Owens Valley PM_{10} Planning Area Demonstration of Attainment State Implementation Plan

Appendices C through K

November 16, 1998

H 1997 SIP Comments and Responses

Figure 1: Outline of Owens Lake showing playa to be treated by area
(Reprinted from Ref. 2)

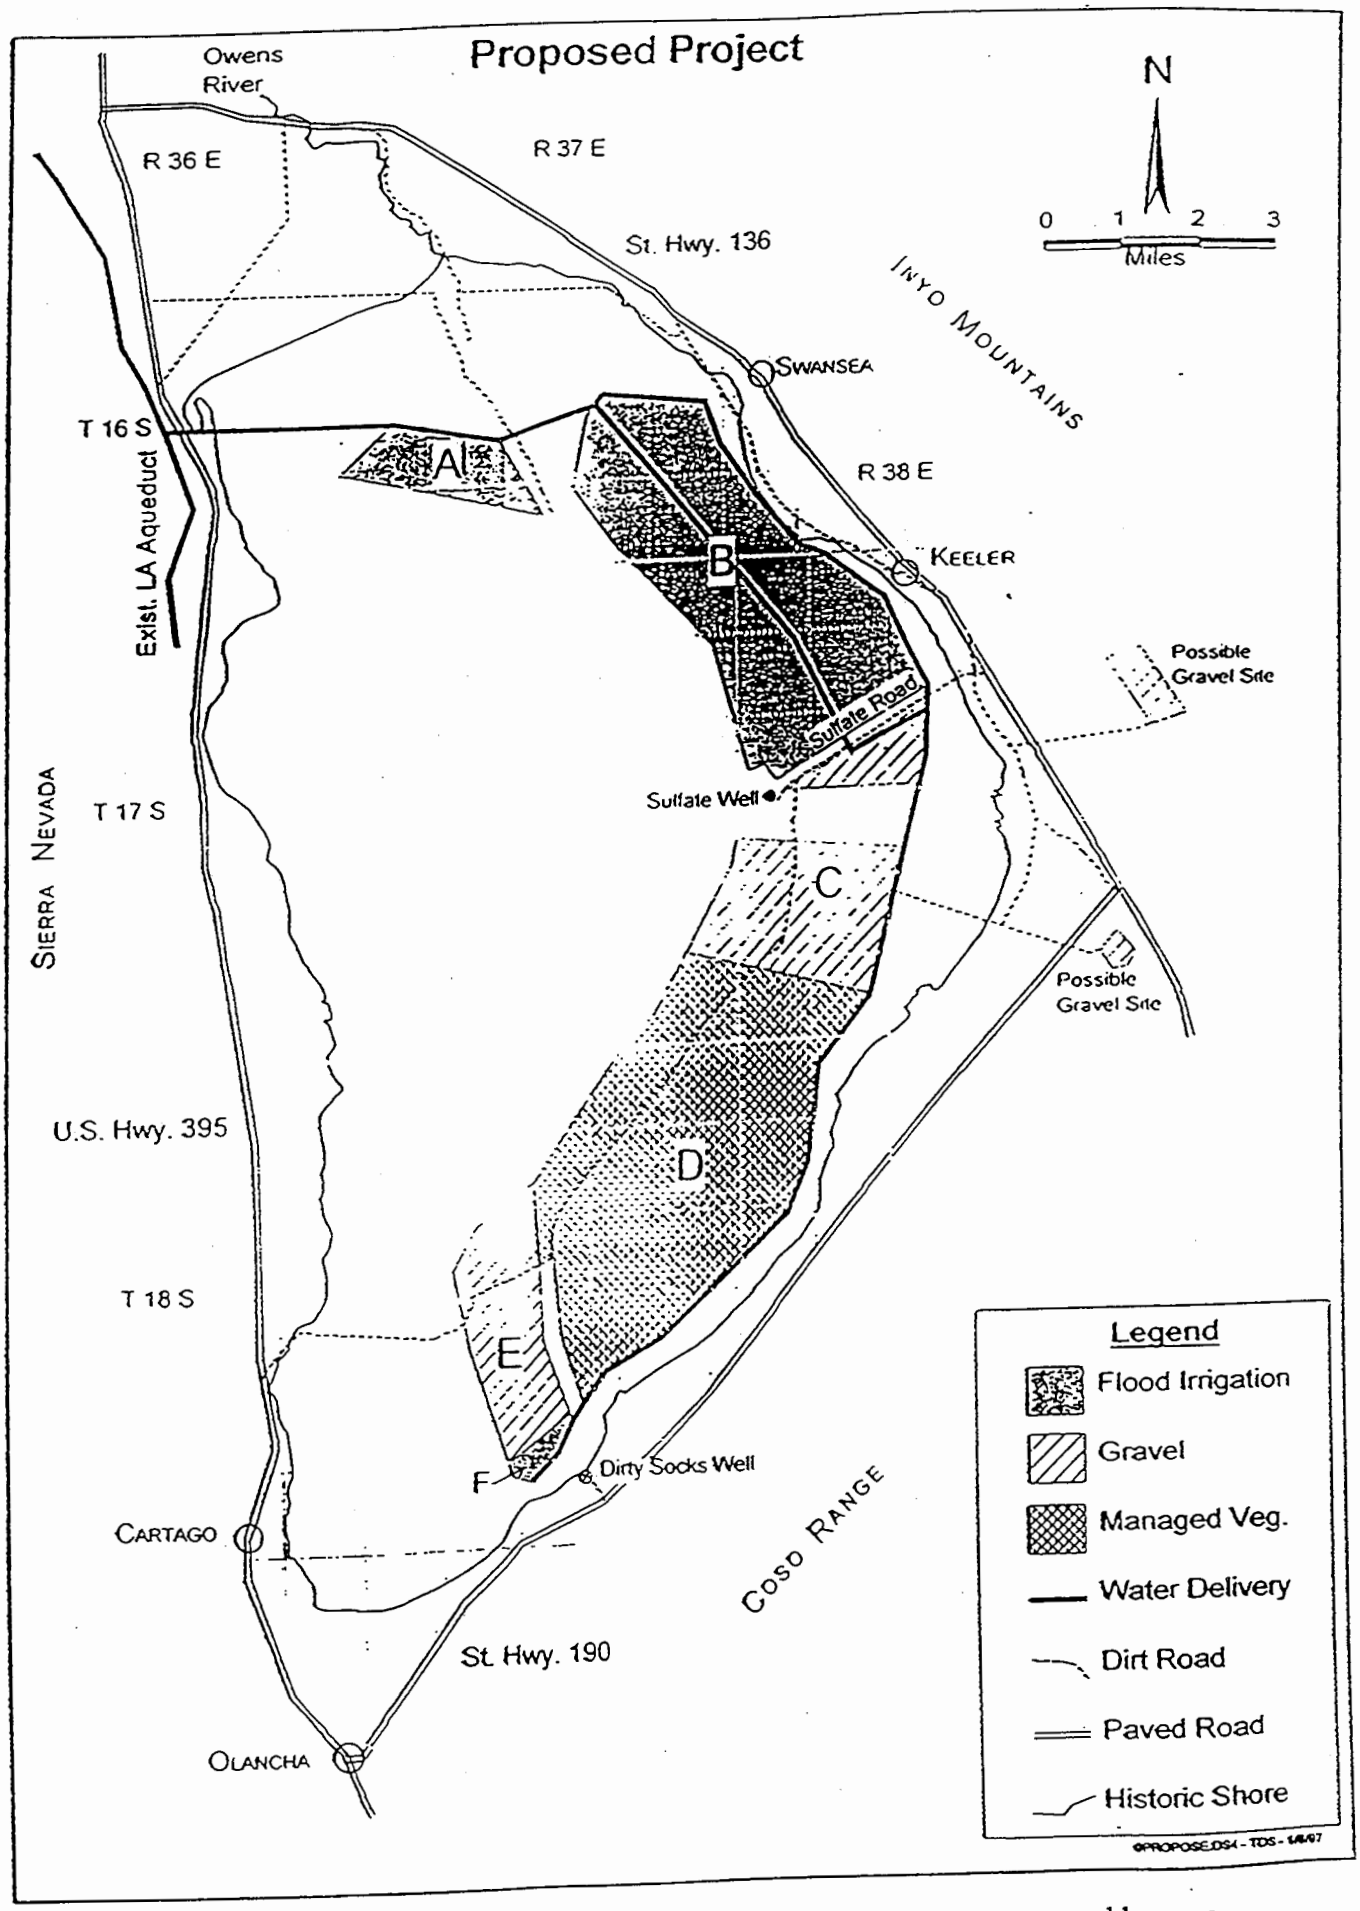
The exposed area covers the eastern part of the lake bed. Figure 1 shows the lake bed.

The dust-generating sections can be classified into six areas, based on soil and drainage patterns. Figure 1 shows the areas, designated A through F.

Areas A, B, and F have a relatively thick layer of sand covering the surface. Area D has a thin layer of sand overlaying a thick clay bed. Areas C and E have a thick sand layer.
